ADDENDUM NO. 2

September 19, 2025

VALE FACILITY ADDITION/RENOVATIONS AND MAINTENANCE/IT FACILITY PROJECTS

Addendum Two (AD.02) to the drawings and specifications prepared by Gibraltar Design for **Valparaiso Vale Facility Addition/Renovations and Maintenance/It Facility and Related Work** for Valparaiso Community Schools, Valparaiso, Indiana.

SHEET
C-101

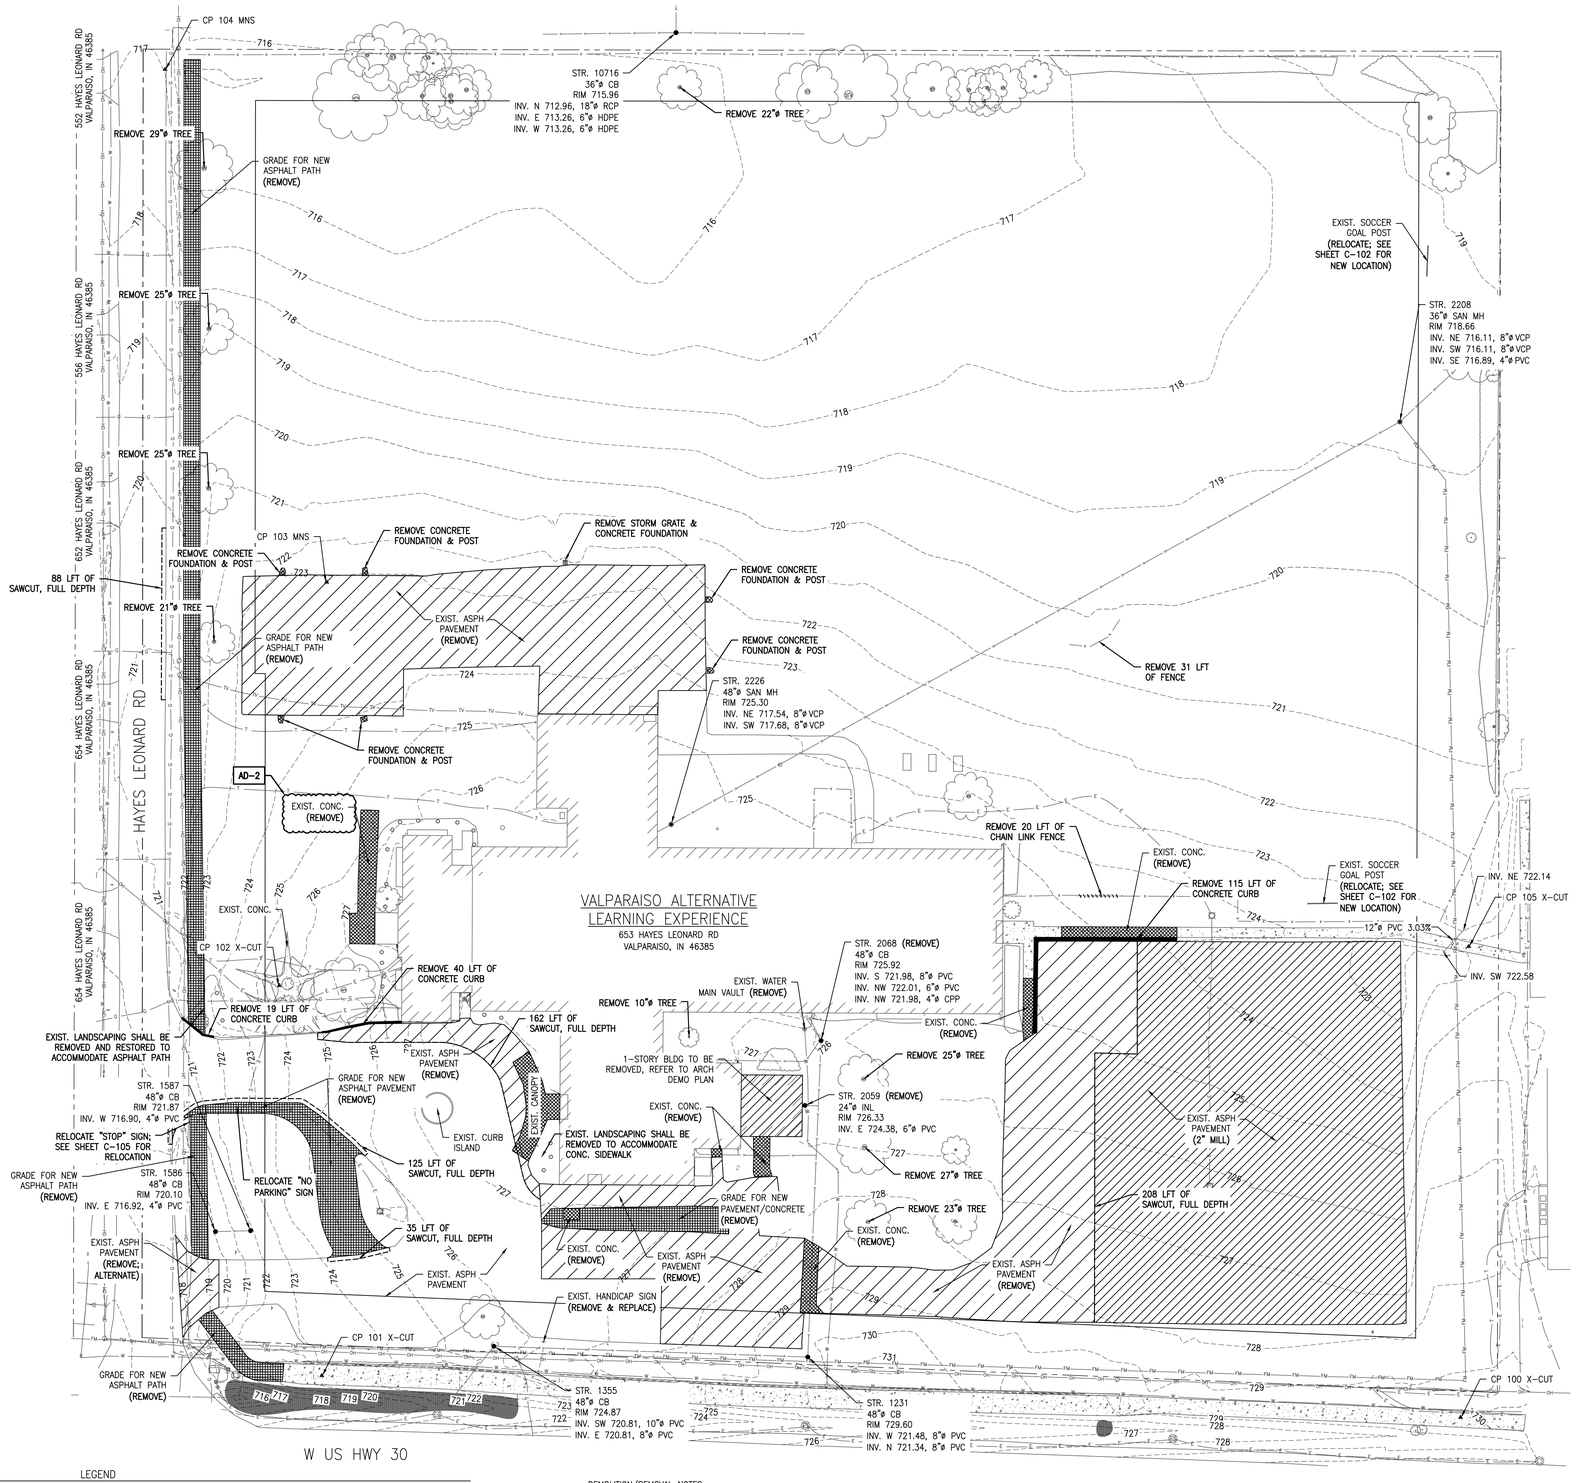
9. Sheet C-101

A. Refer to revised, full-size drawing, included in this Addendum, for revisions below.

SHEET
C-104

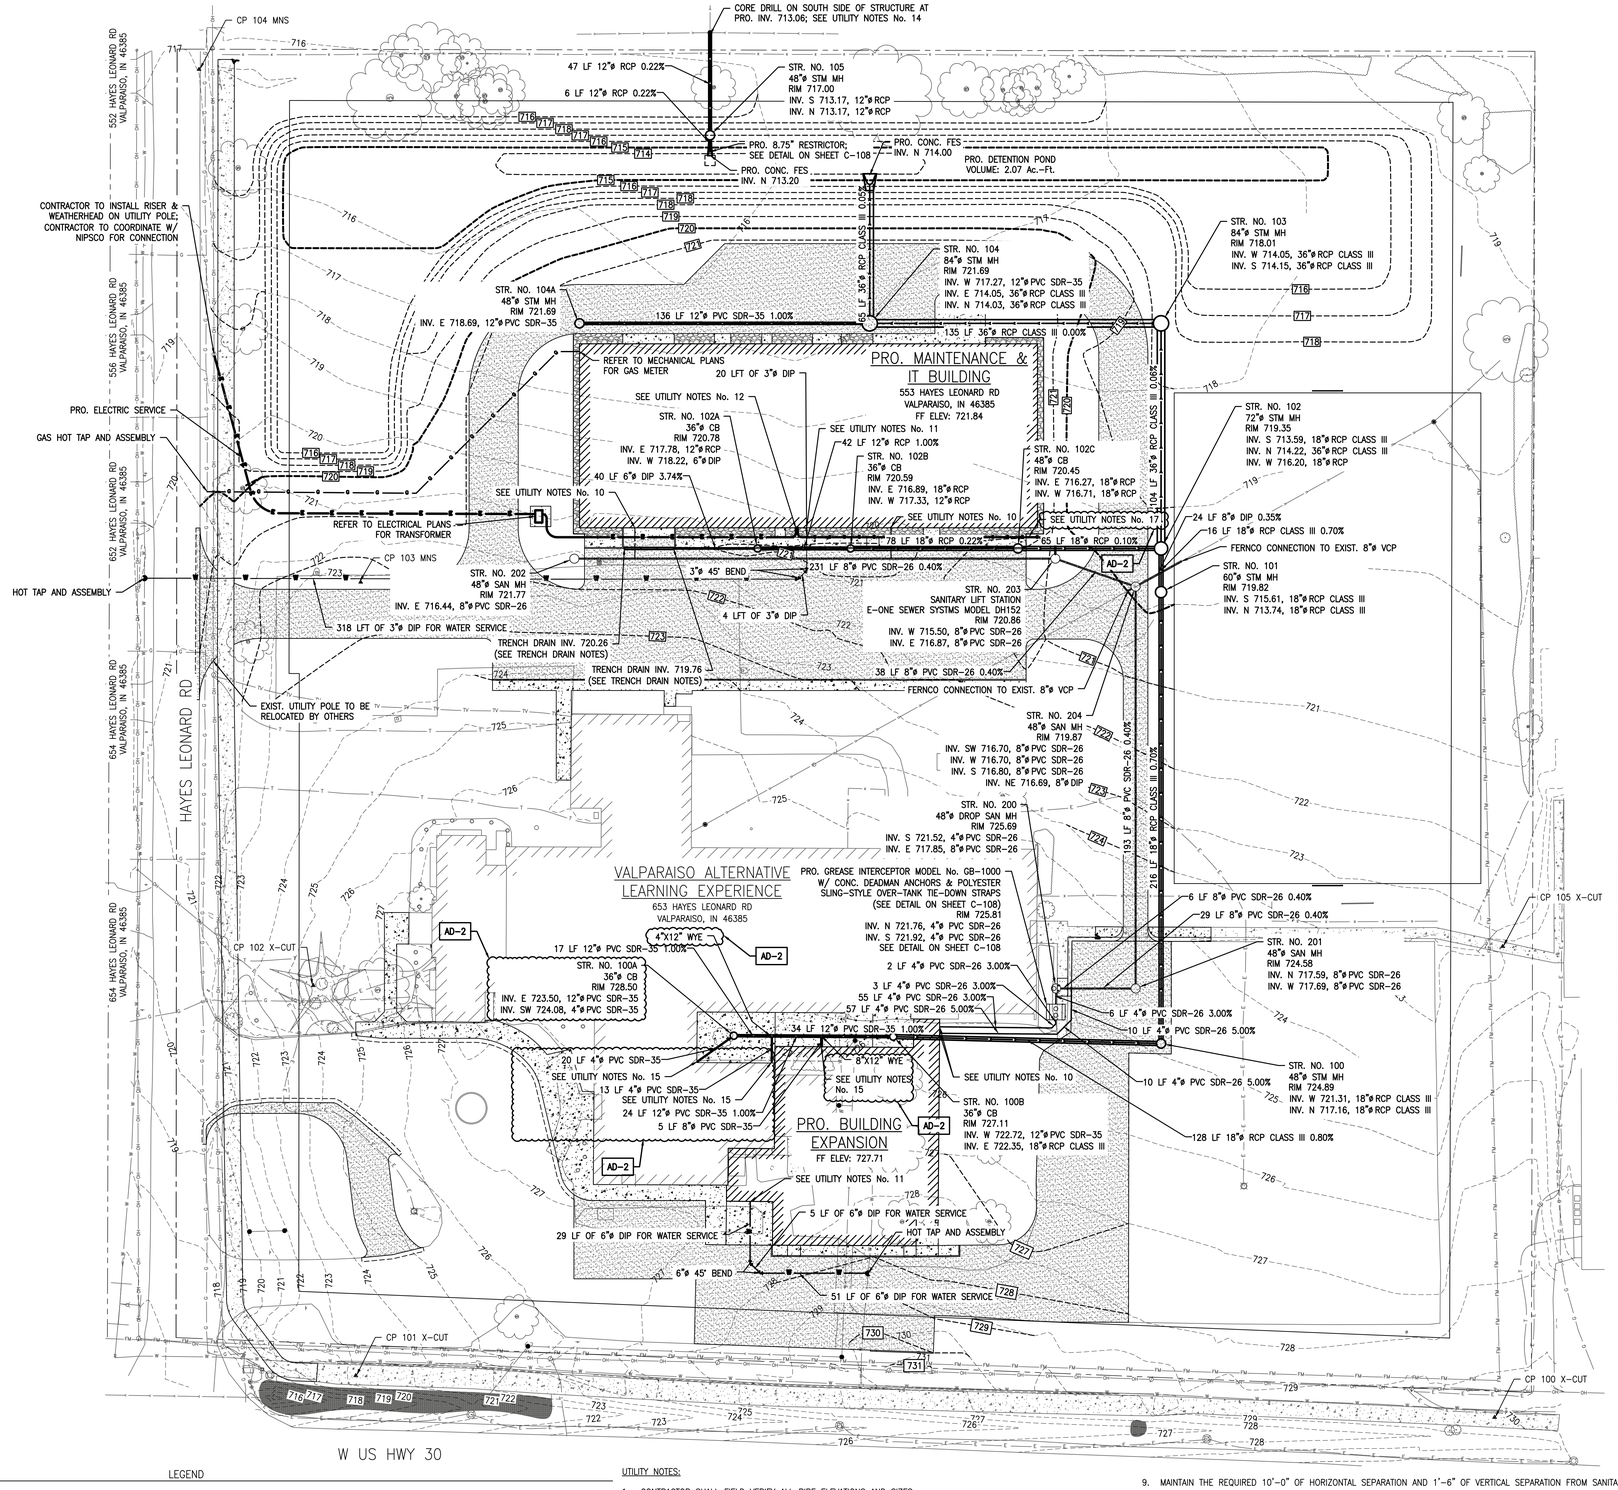
10. Sheet C-104

1. Revised note #15 to "Utility Notes".
2. Added notes #16 and #17 to "Utility Notes".
3. Added an electrical single line diagram for the sanitary lift station.
4. Added 4" Dia. storm downspout pipes.
5. Connected 4" Dia. storm downspout pipe to STR. 100A with pipe invert.
6. Added 4"x12" WYE for downspout connection to header pipe.
7. Added 8" Dia. storm downspout pipe.
8. Added 8"x12" WYE for downspout connection to header pipe.

1 A-101 1/8" = 1'-0"

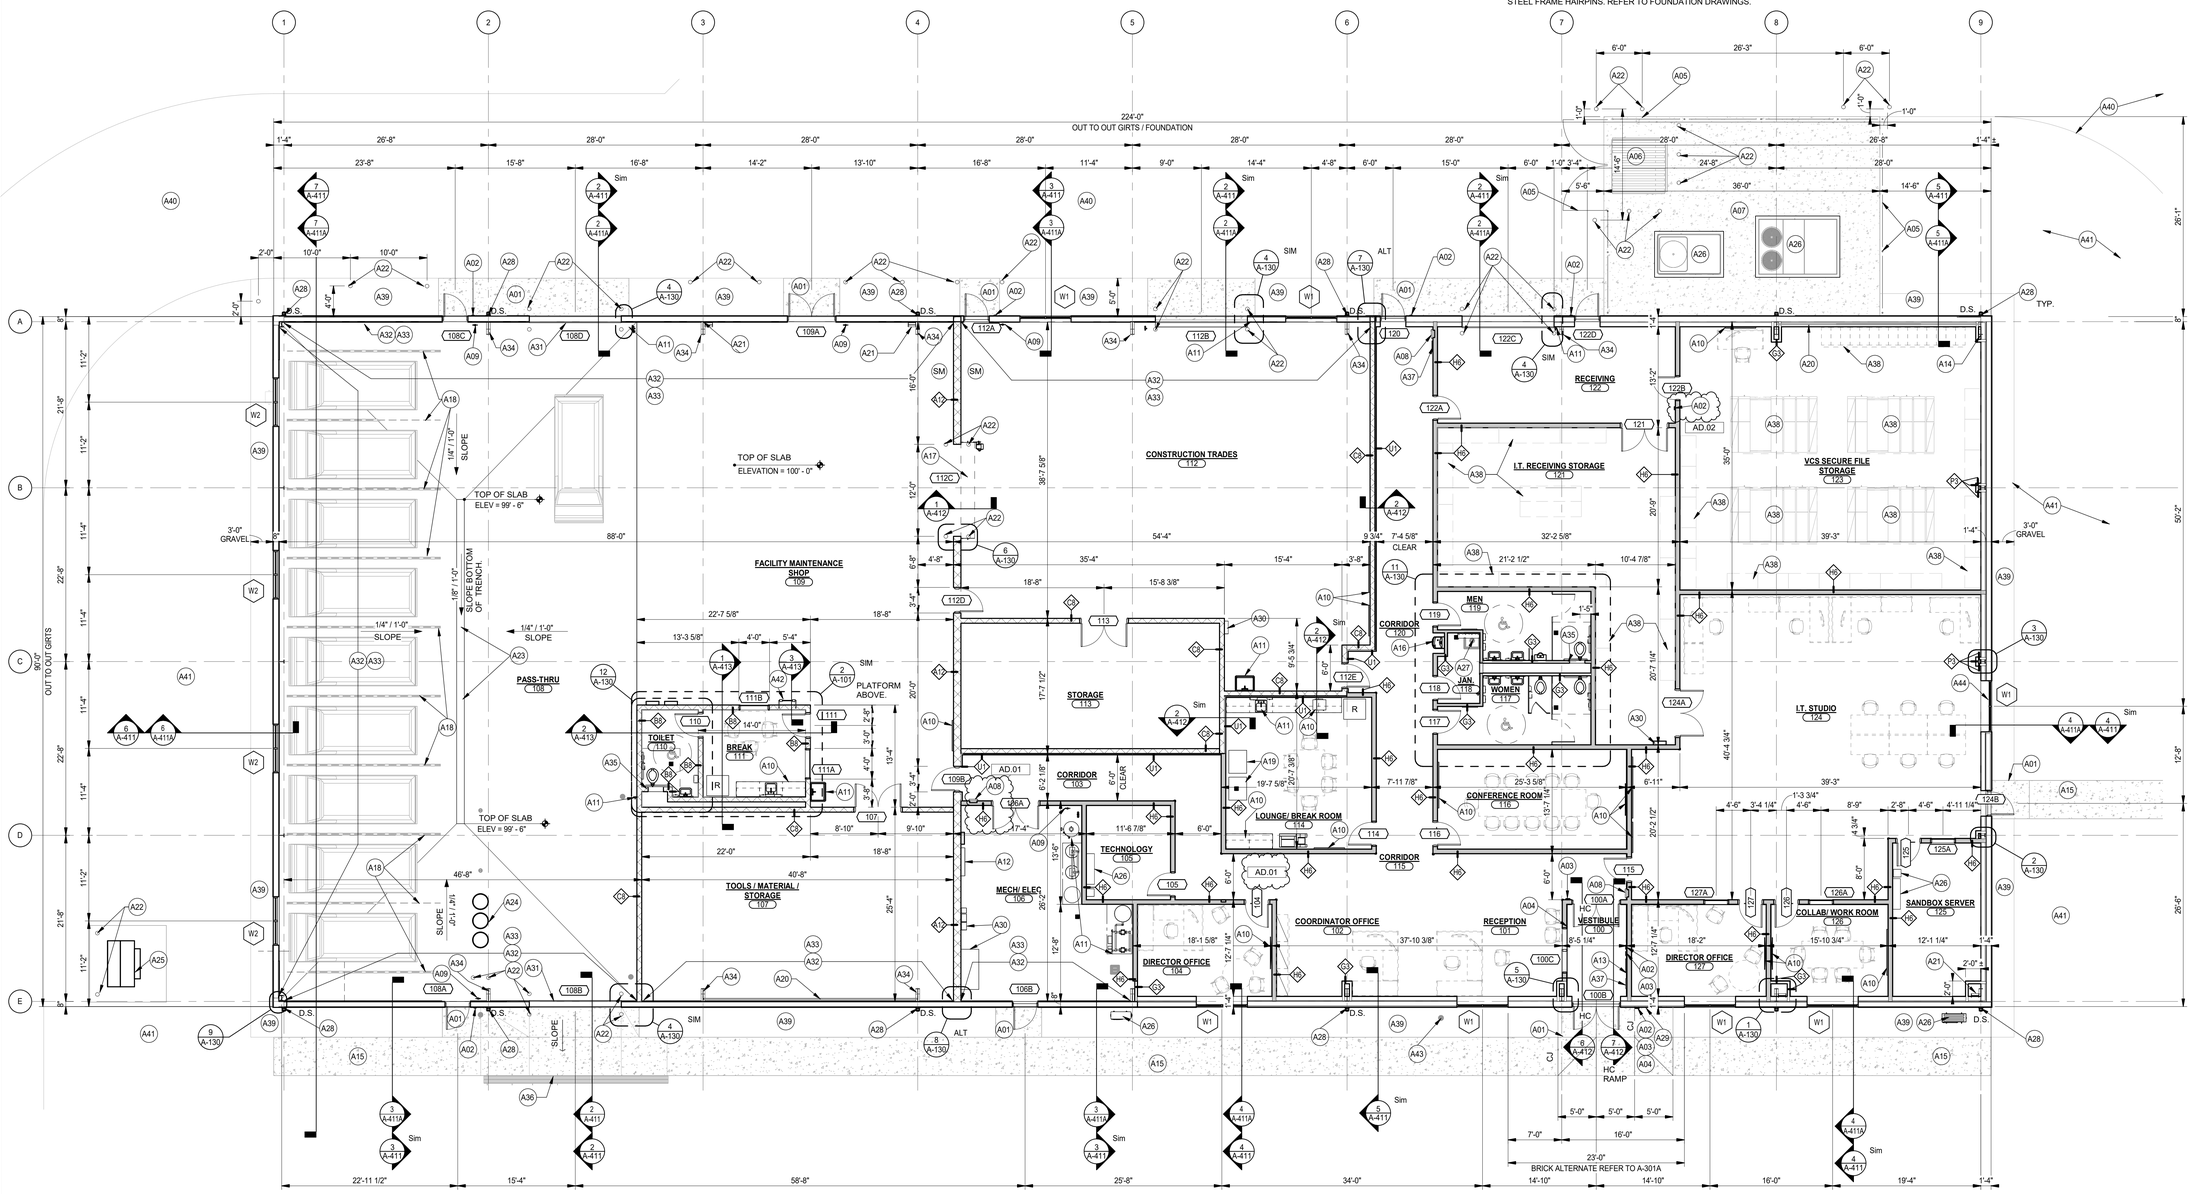
14. Sheet A-101

1. Added card reader.
2. Revised Architectural plan note A07.
3. Deleted General note M.

SHEET
A-301

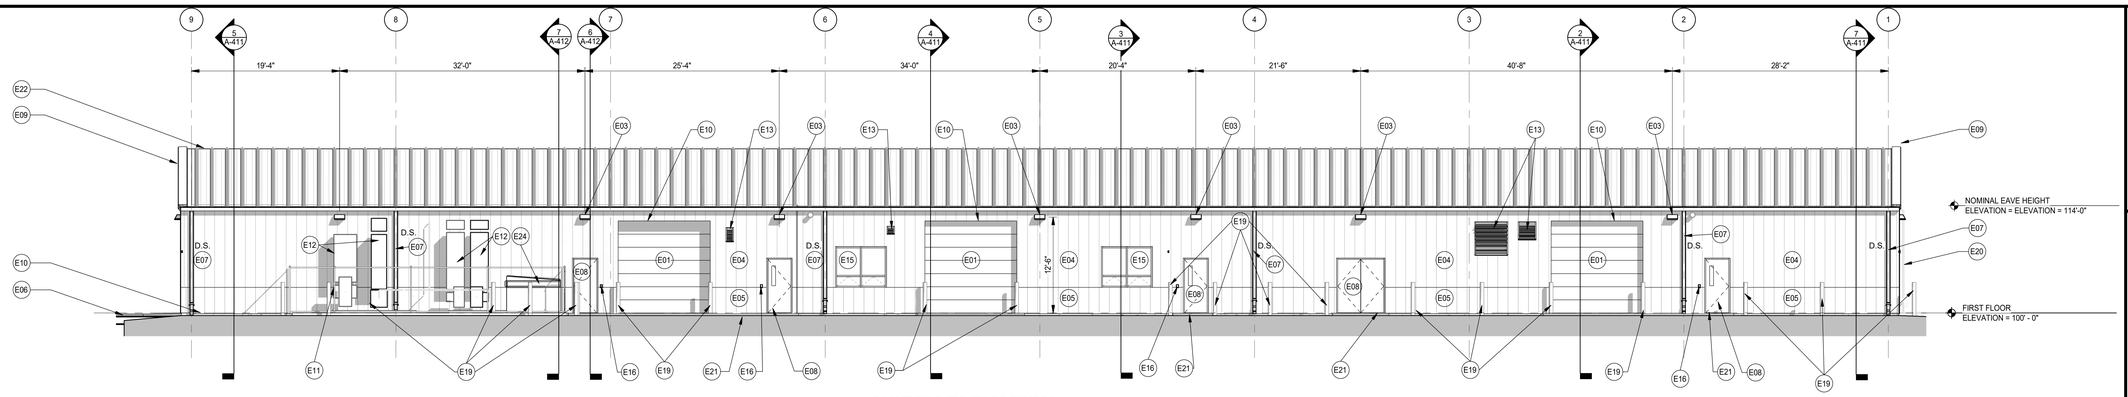
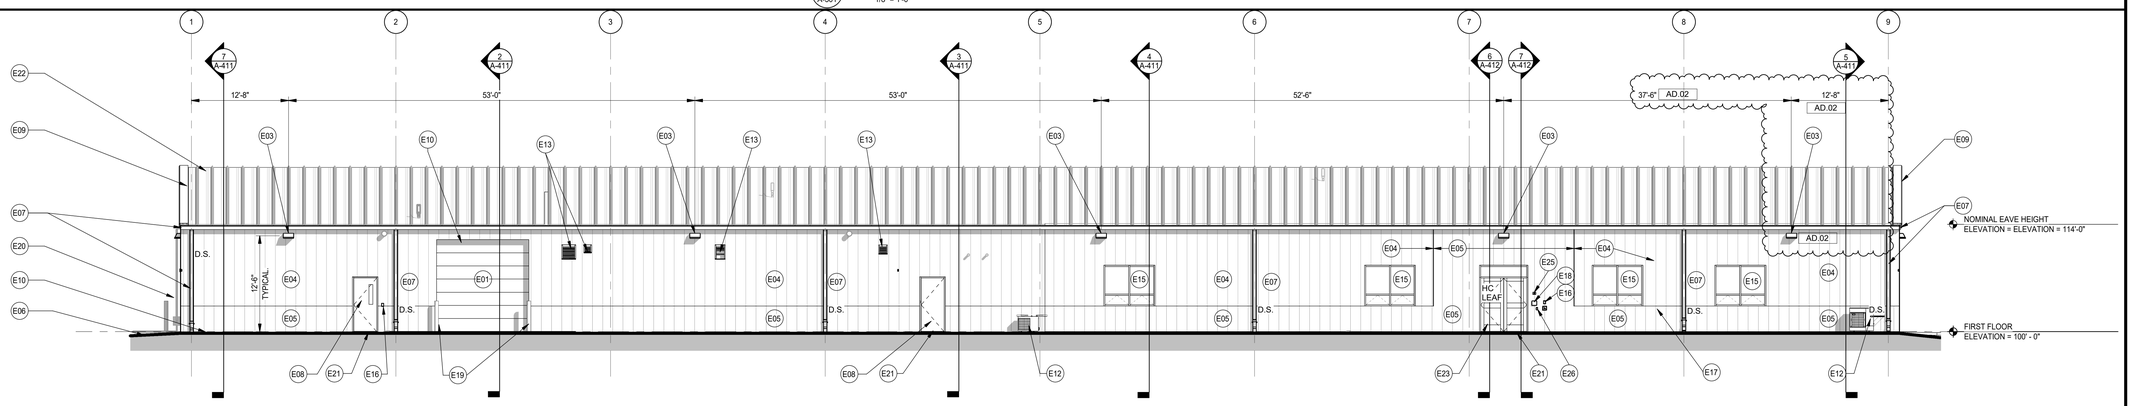
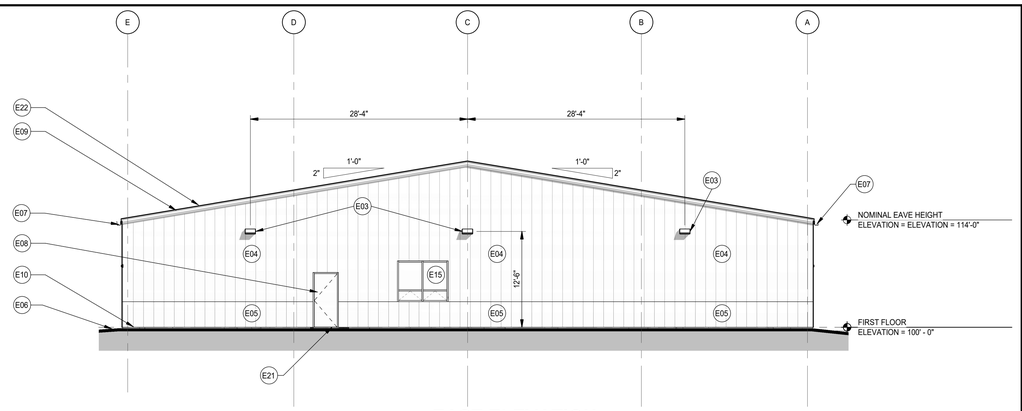
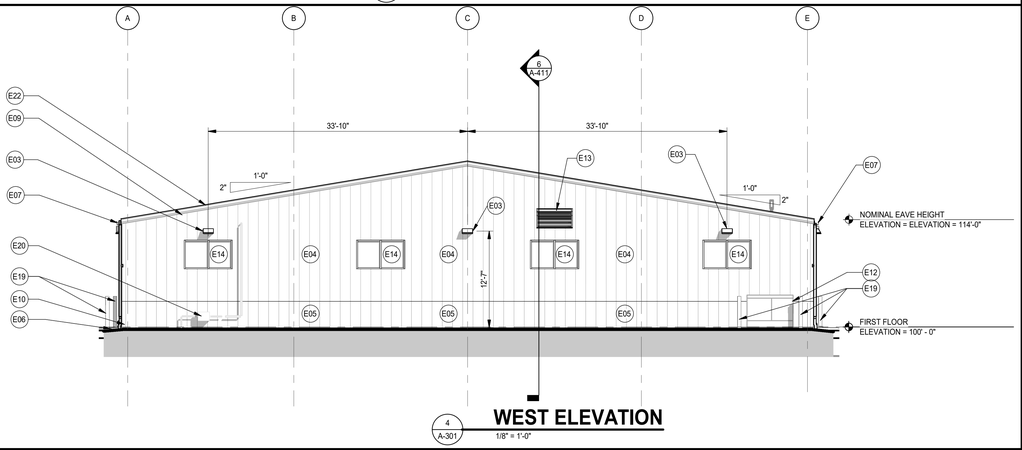
38. Sheet A-301

1. Added top of masonry elevations and eliminated detail 13.

SHEET
A-411

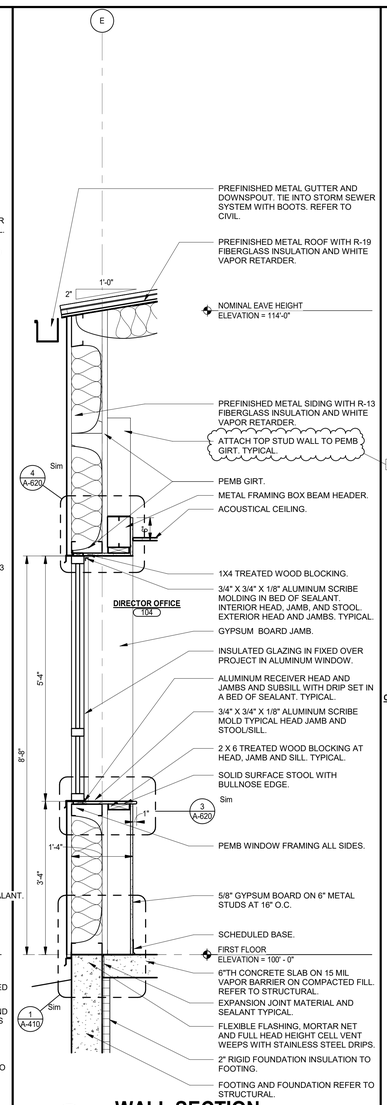
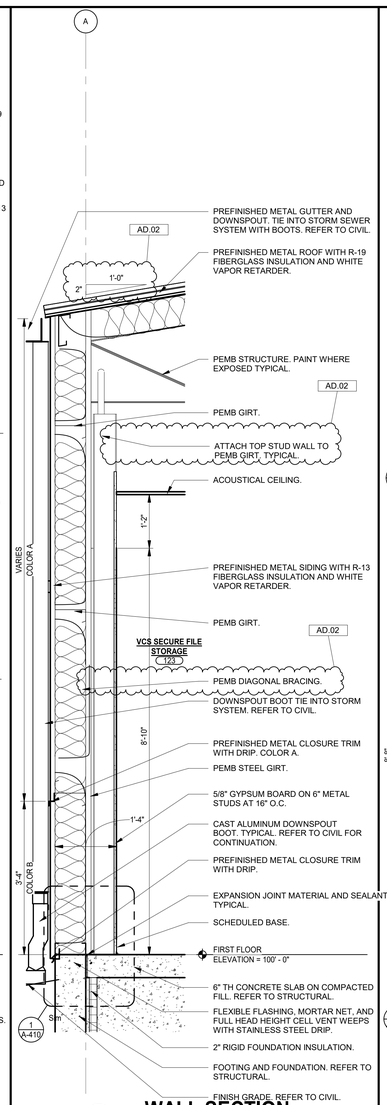
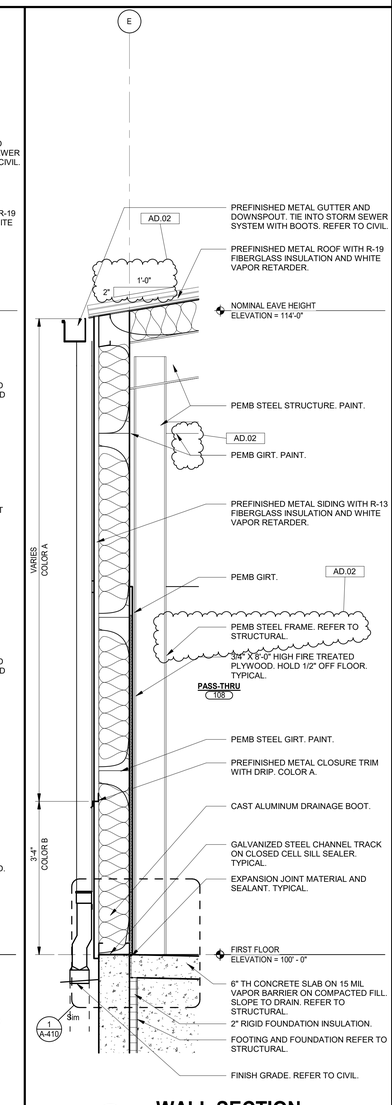
1. Revised sections 1/A-411, 4/A-411 and 5/A-411.
